### 3 COMMENTS AND RESPONSES

#### 3.5.3 Response to Letter D3: SDG&E

Figure 3.5-5 No Project Alternative (Revised)

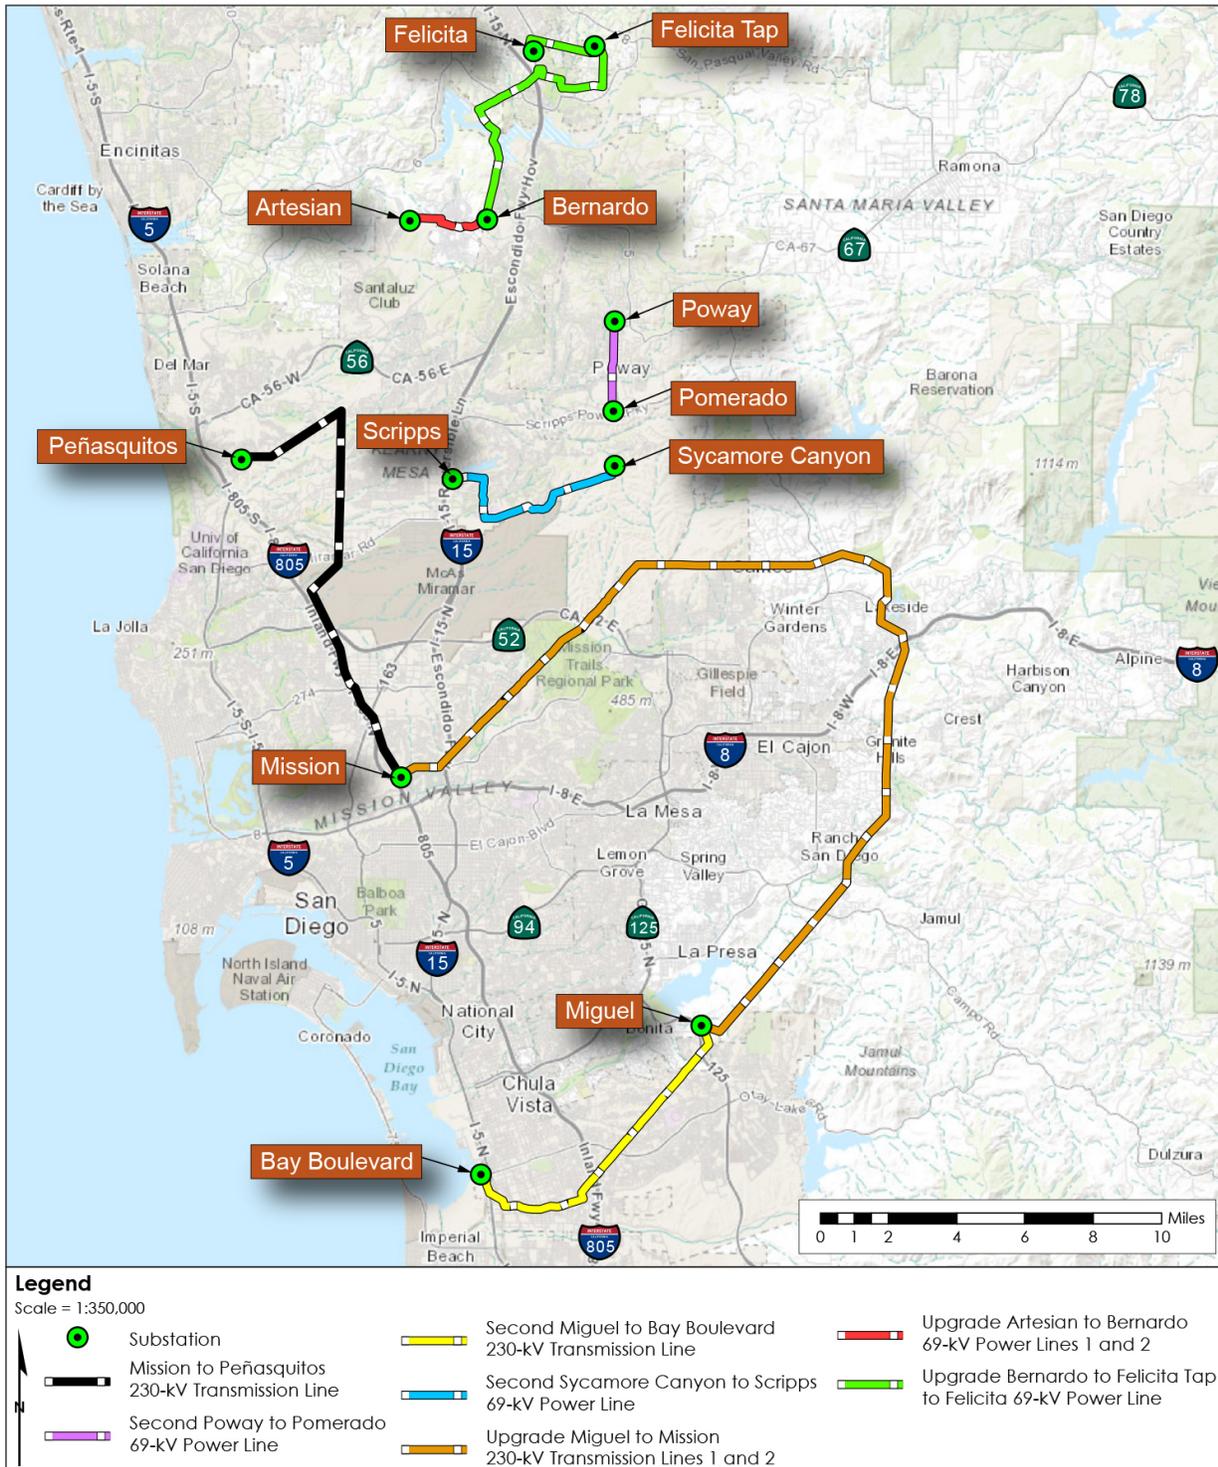
D3-11 In response to this comment, the CPUC prepared a data request to obtain further information from SDG&E regarding the definition of the No Project Alternative. SDG&E submitted information in Response to Data Request #18 and #21 regarding the upgrades that would need to occur if the Proposed Project were not constructed (SDG&E 2015b). SDG&E explained that construction of the Mission—Peñasquitos 230-kV transmission line project and Second Poway—Pomerado 69-kV power line project would be incremental to and not a substitute for the Proposed Project. SDG&E further explained that adding a shunt reactor to Sycamore Canyon Substation would not increase the current-carrying capability in the transmission network but rather shunt the flow of power elsewhere in the network. Adding a shunt reactor would therefore not help relieve congestion in the transmission system and would not help meet project objectives.

Section 3.5.6 of the Draft EIR has been revised to re-define the No Project Alternative, as shown below. The shunt reactor was removed and the five upgrades listed by SDG&E were added to the No Project Alternative. The impact analysis of the No Project Alternative has been revised in Sections 4.1 through 4.17 of the Draft EIR to reflect the revisions shown below. Chapter 3: Alternatives and Chapter 6: Comparison of Alternatives have also been revised to reflect the revisions shown below.

The corridors for these upgrades are shown on Figure 3.5-5. The last five improvements were defined by SDG&E in rebuttal testimony (SDG&E 2015a) and response to comments on the Draft EIR and subsequent CPUC data requests (SDG&E 2015e, 2016a).

**Figure 3.5-5 Alternative 5 Staging Yards**

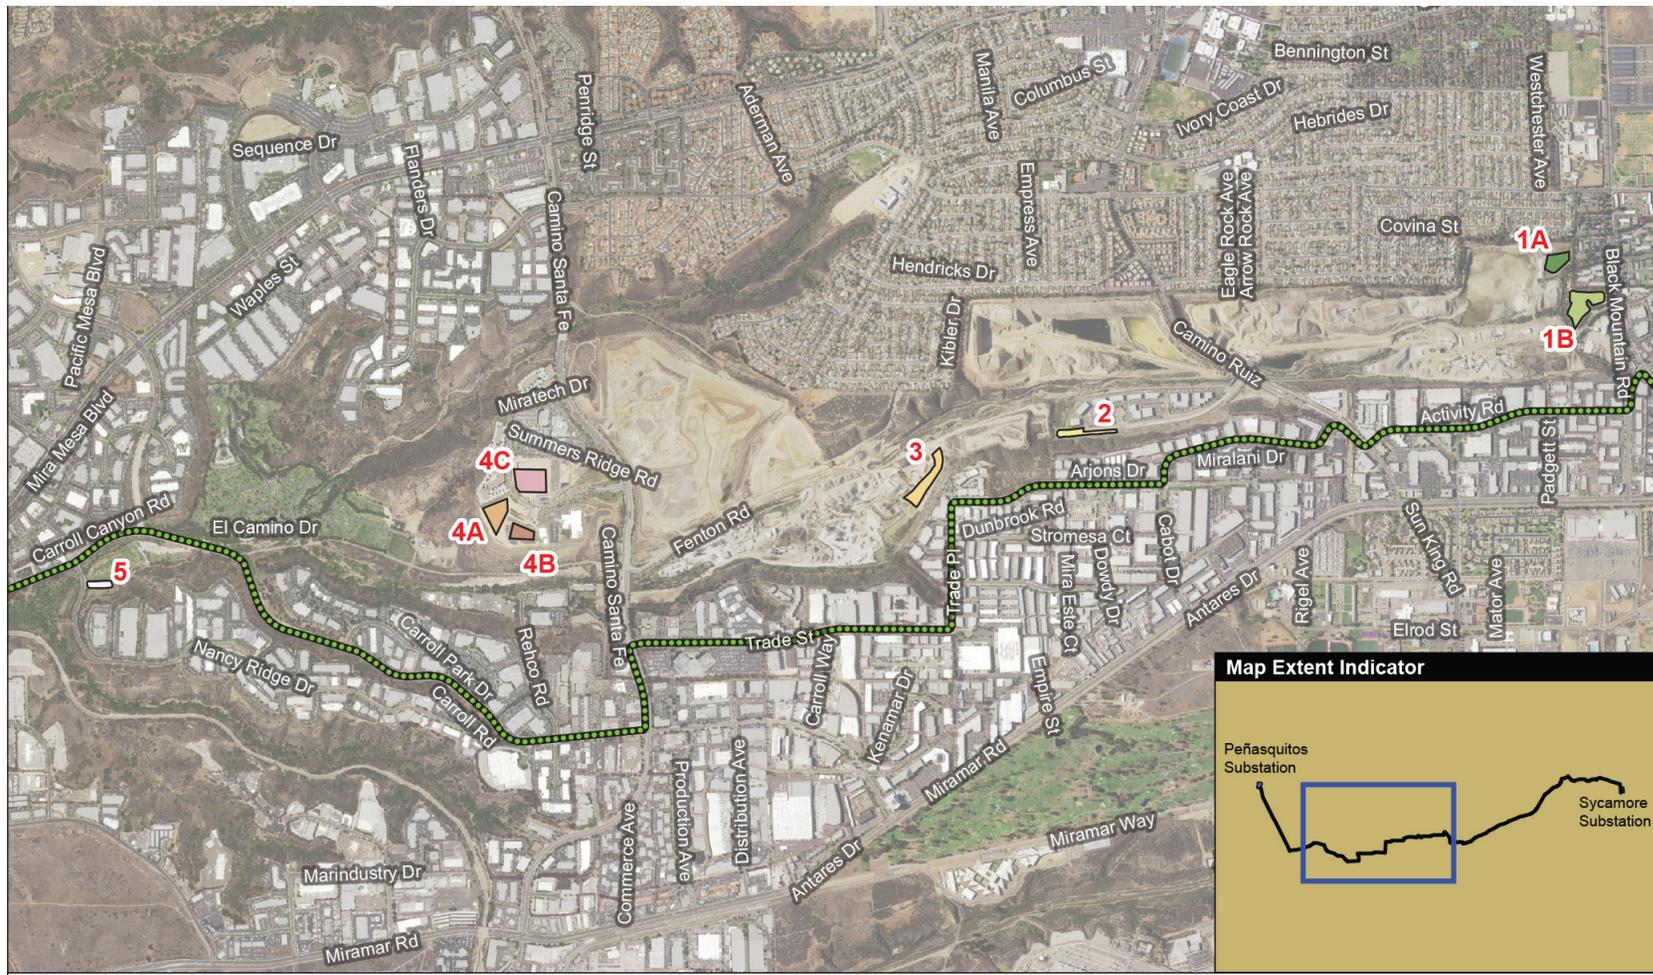
- D3-15 The CPUC reviewed SDG&E's request to consider additional staging yards that may be used during construction of Alternative 5. Subsequent to this comment, the CPUC requested information on specific staging yard locations and activities in response to this comment and the staging yard locations provided in Attachment B, Exhibit 11 of SDG&E's comment letter. In response to CPUC Data Request #22, SDG&E defined specific staging yard areas for Alternative 5. The Alternative 5 staging yards would be located on previously disturbed lands, including graded and paved areas and areas within active quarries. SDG&E proposed these staging yards because they would be located considerably closer to the Alternative 5 underground alignment (within 0.5 mile) than the Proposed Project staging yards (between 0.6 and 7 miles from the underground alignment). The Alternative 5 staging yards would be used in conjunction with the Proposed Project staging yards should the CPUC approve Alternative 5. The Alternative 5 staging yards would be used for materials storage and equipment staging for construction of the underground transmission line; these staging yards would not be used as helicopter landing areas.

Chapter 3: Alternatives, Section 3.5.5 of the Draft EIR has been revised to describe the Alternative 5 staging yards as follows:

Alternative 5 ~~would~~ could utilize the same staging yards and materials storage areas as the Proposed Project and up to eight additional staging yards for Alternative 5 equipment staging and materials storage (SDG&E 2016). The Alternative 5 staging yards locations are shown on Figure 3.5-5. Table 3.5-3 lists the staging yards and the acreage of each yard. The Alternative 5 staging yards would be used for materials storage during Alternative 5 underground transmission line construction activities (trenching, vault installation, and cabling). Helicopter activities (landing and fueling) would not occur at these staging yards; Proposed Project staging yards would be used where helicopter activities are required. Spare underground PVC conduit may be temporarily stored along roadways during construction.

Figure 4.1-2 Critical Habitat within the Proposed Project Vicinity (Revised)

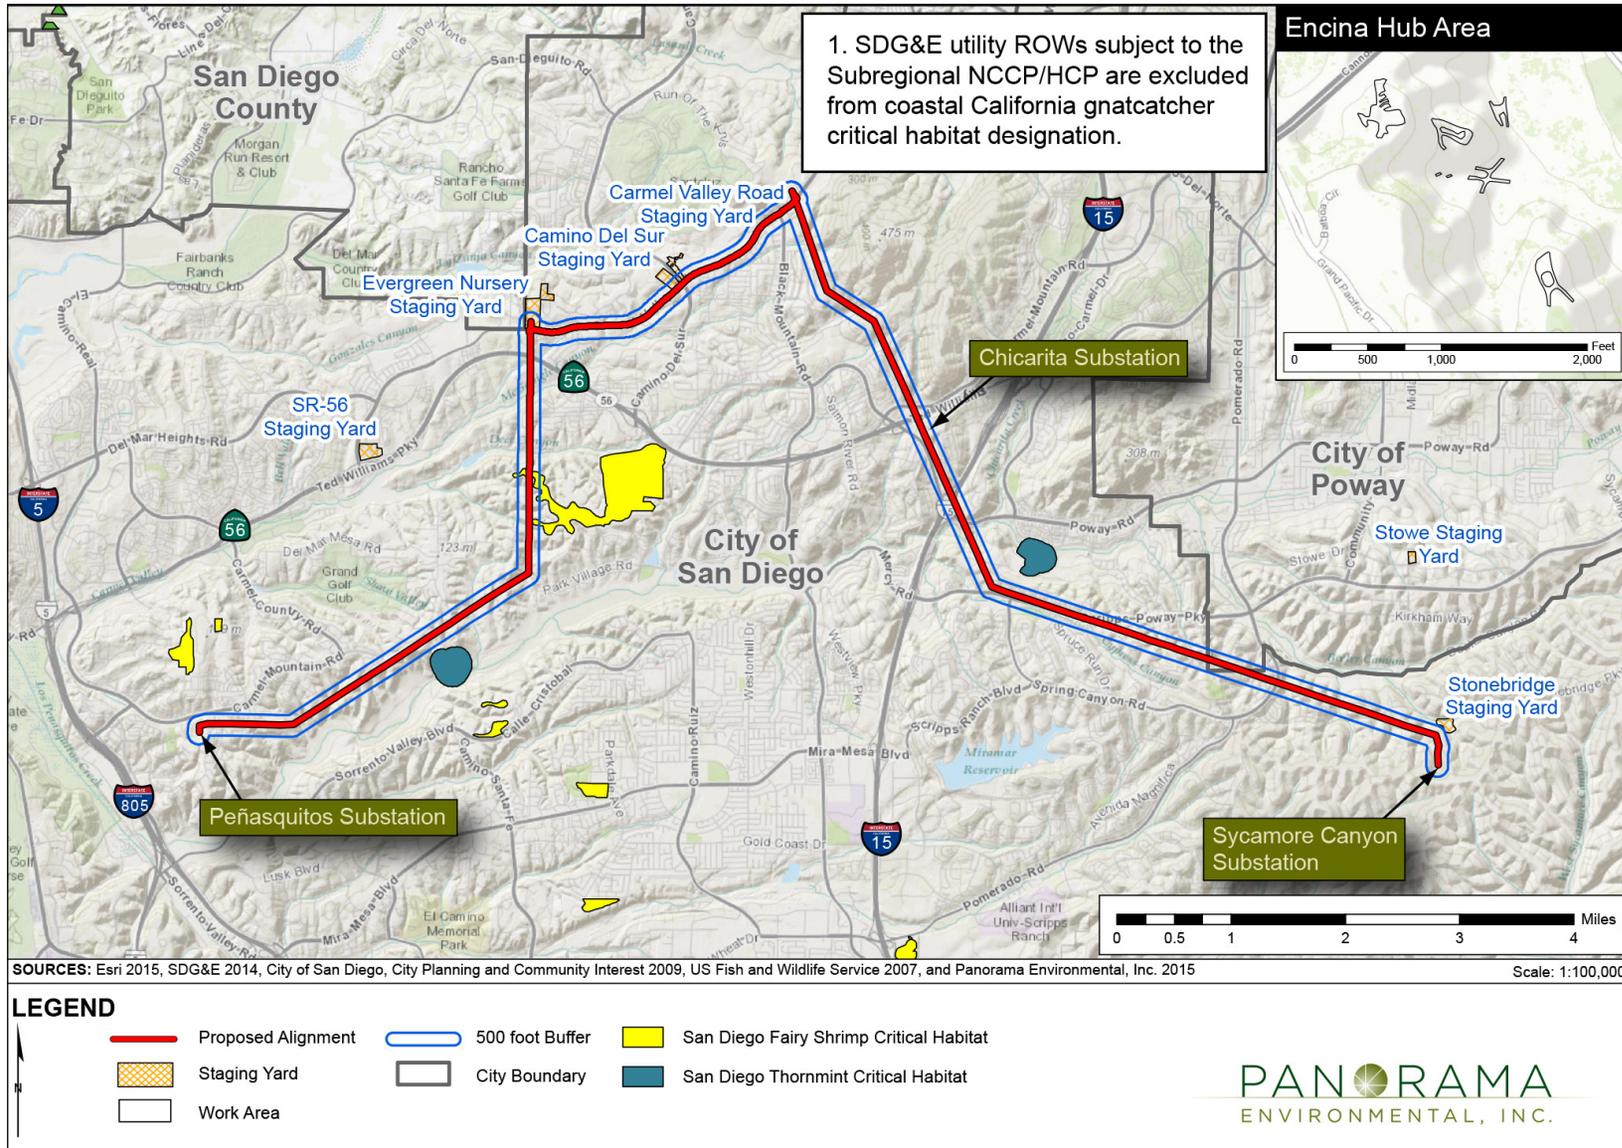
D3-37 See response to comment D3-36. Critical habitat for coastal California gnatcatcher is exempt within SDG&E ROW, including within the Encina Hub work site. Figure 4.1-2 of the Draft EIR has been modified to show that critical habitat is not located within the Encina Hub work area, as shown below.
